[1] REDLINE REVISION NO. 1 — JANUARY 2010
TEDD APPROVAL — SHA NO. W16491580

US 13 BUSINESS (N. SALISBURY BOULEVARD)
AT CHURCH STREET
ULTIMATE SIGNAL

SIGNALIZATION PLAN SHEET

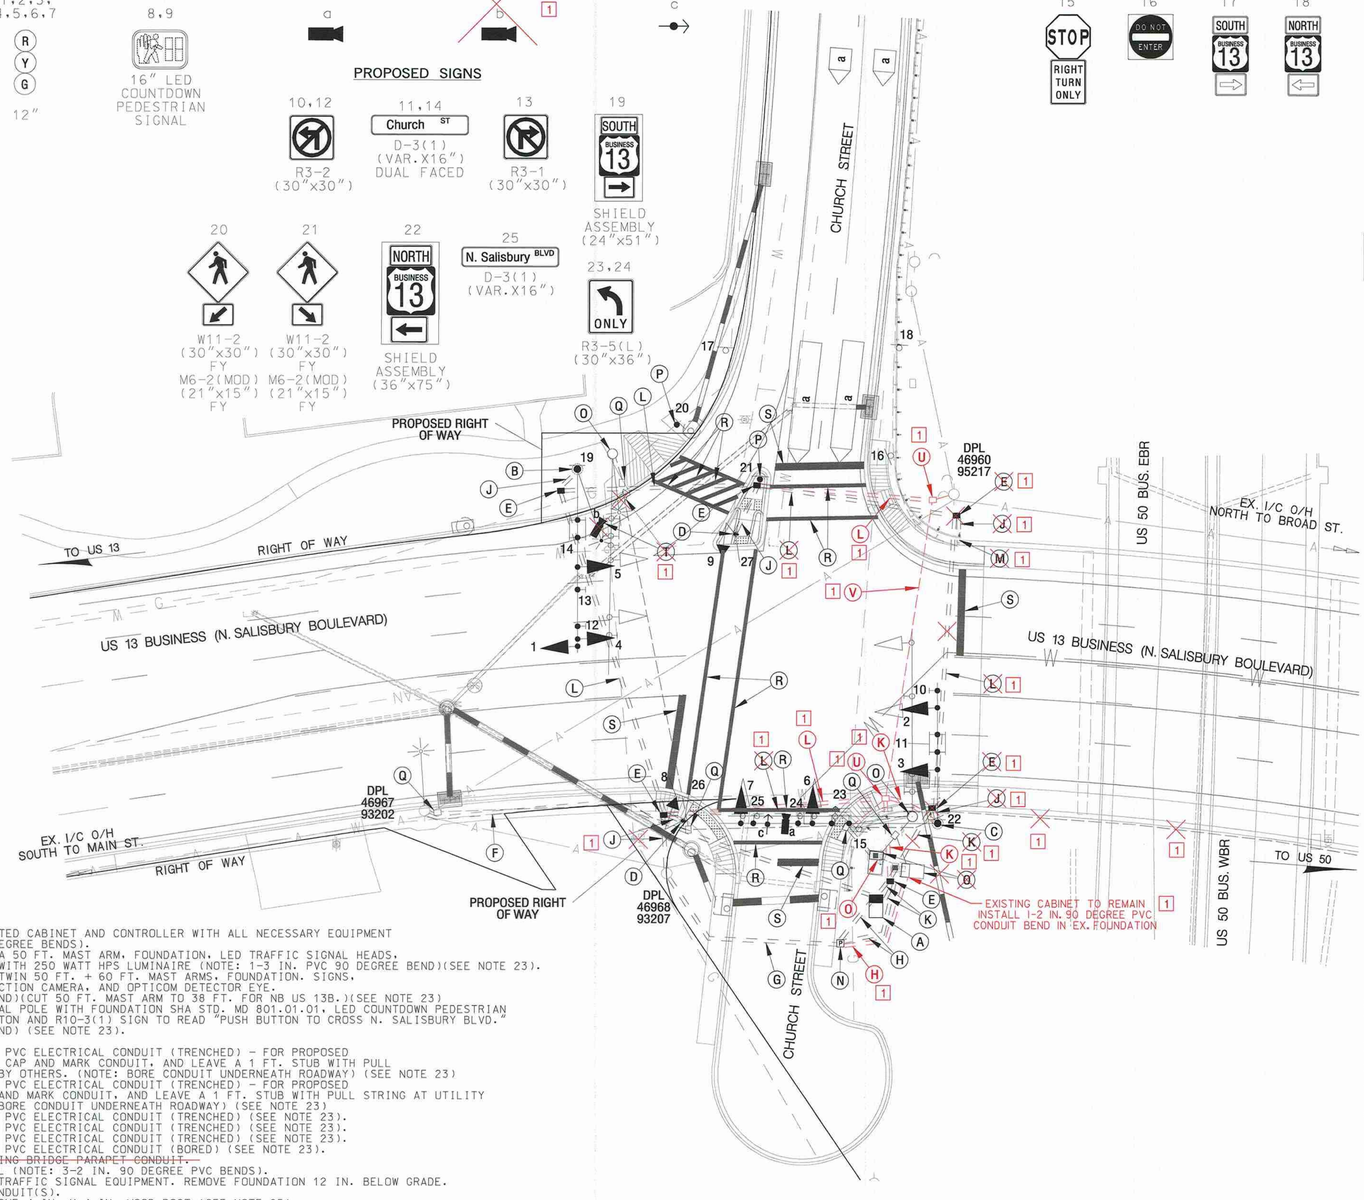
RELOCATED VIDEO DETECTION CAMERA

b [1]

K. INSTALL 4 IN. SCHEDULE 80 RIGID PVC ELECTRICAL CONDUIT (TRENCHED) (SEE NOTE 23).
L. INSTALL 4 IN. SCHEDULE 80 RIGID PVC ELECTRICAL CONDUIT (BORED) (SEE NOTE 23).
[1] ~~M. TIE PROPOSED CONDUIT INTO EXISTING BRIDGE PARAPET CONDUIT.~~

R. INSTALL 12 IN. WHITE PREFORMED THERMOPLASTIC PAVEMENT MARKINGS FOR CROSSWALK (SEE NOTE 22).
S. INSTALL 24 IN. WHITE PREFORMED THERMOPLASTIC PAVEMENT MARKINGS FOR STOPLINE (SEE NOTE 22).
[1] ~~T. RELOCATE EXISTING VIDEO DETECTION CAMERA ONTO PROPOSED LIGHTING ARM.~~
[1] U. USE EXISTING HANDHOLE.
[1] V. USE EXISTING CONDUIT.
